KMR.CDD.RaQ.1920.02

No. L. S. 7022 OF 1920

PLOT NO 47 SHEET E 6.
RAMASWAMY QUARTER

I beg to inform you that I intend building making additions & alterations to temple on plot No. 47
Survey Sheet No. 8.6 situate in Toolsee & Pitarner
Street Ramaswamy Quarter.

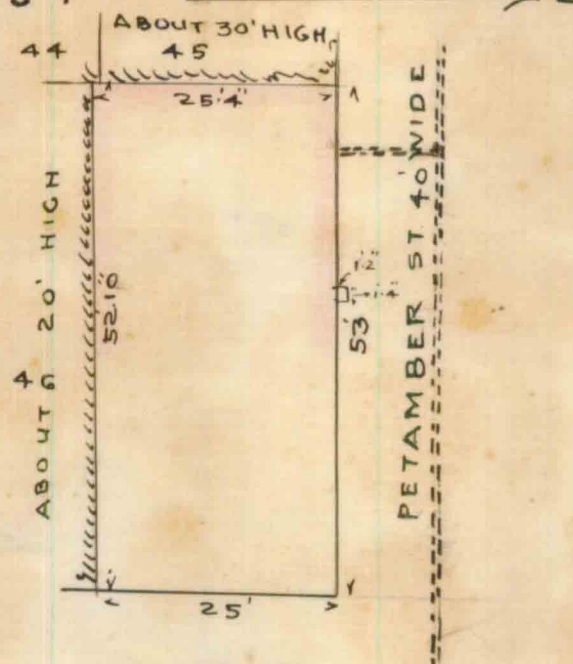
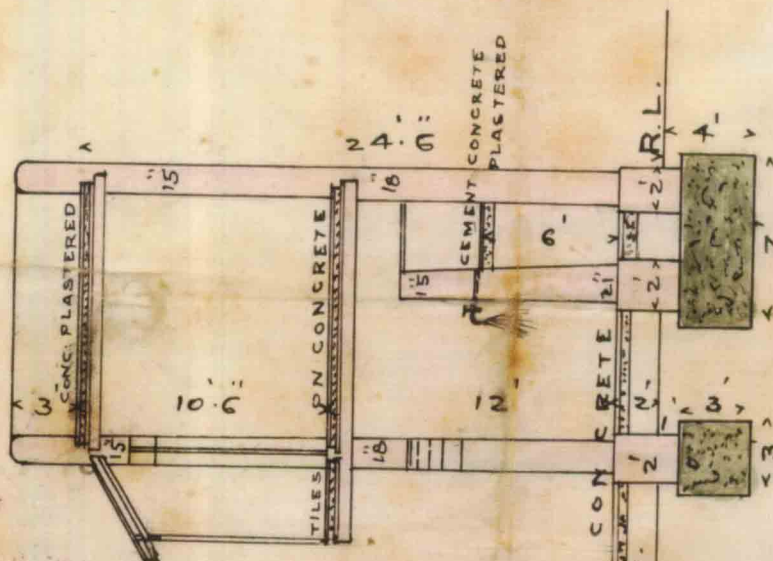
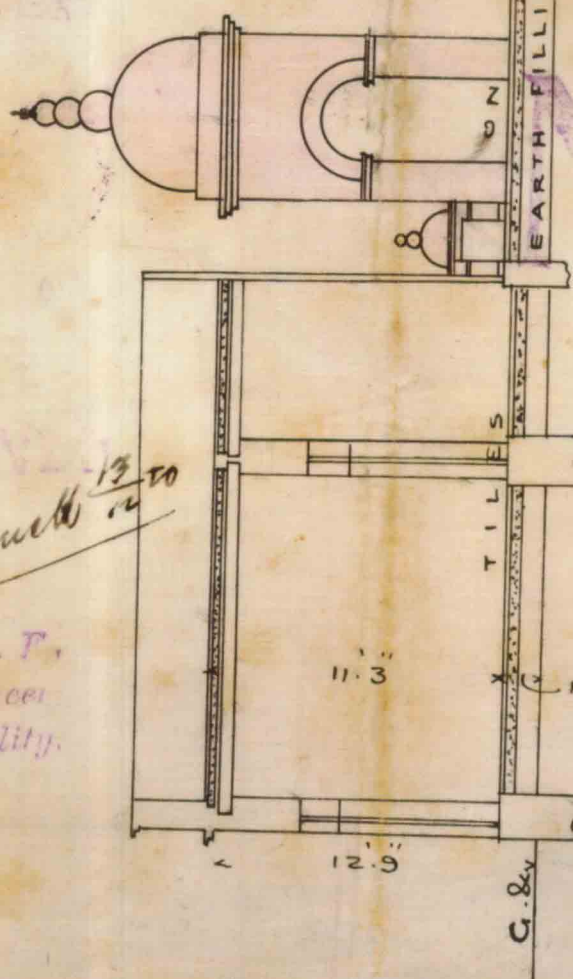
Hearing that the owner of my adjoining plot no 47 & Ramswami Quarter has submitted a plan to the municipality for erecting a building thereon and if his plan will be sanctioned by the municipality my house which is on plot no 45 & Ramswami Quarter will be quite unsanitary and unfit for human habitation as there are only four small ventilators from my plot, opening on that plot, from which I get through ventilation and if the ventilators will be closed my rooms will be quite dark and useless. I therefore request your honour not to allow him to close my windows and also visit the site before passing the plan for which act of kindness I shall ever remain thankful.

With reference to his application dated 22nd ultimo with a plan for the proposed additions and alterations on plot No. 47, E-6 Ramswamy Quarter Mr. Cheena Umersi is informed, the place is being overcrowded and he is trying to block up light and air from his next door neighbour's property.

More open space must be provided.

With reference to this sheet
report the proposed Shiv temple must be erected
in line with the existing temple (7' x 5' 9") & space
kept open to sky.

Sir, With reference to this sheet
report that the open space for such
public function is quite inadequate.
Otherwise seems no objection

The matter makes no
difference & the plan if in order
may be passed

The plan is herewith returned for amendment.

47E.6

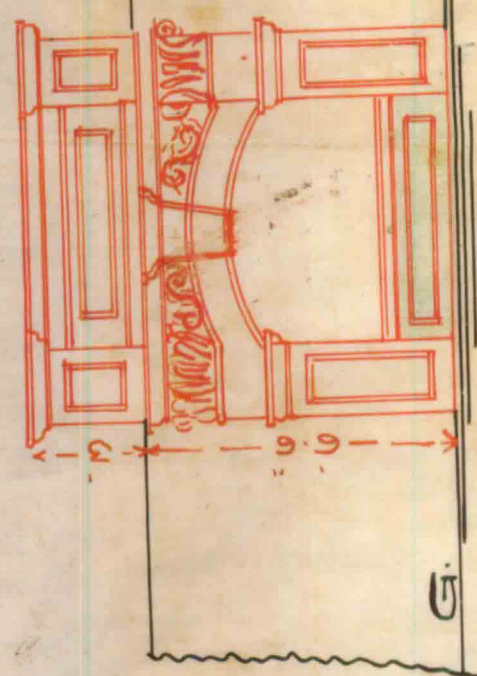
With reference to his application dated 2nd instant with a sketch for the proposed watertrough on plot No 47 E 6 Ramsamy quarter, Mr Khimji Bhanji is informed, the application must come through the owner of the plot accompanied by a proper plan signed by an architect, when it will be considered.

No objection  
 but the place must be  
 connected with drainage  
 7<sup>th</sup> 19

Otherwise there is no  
objection to the proposed  
work if connected with  
drainage system.
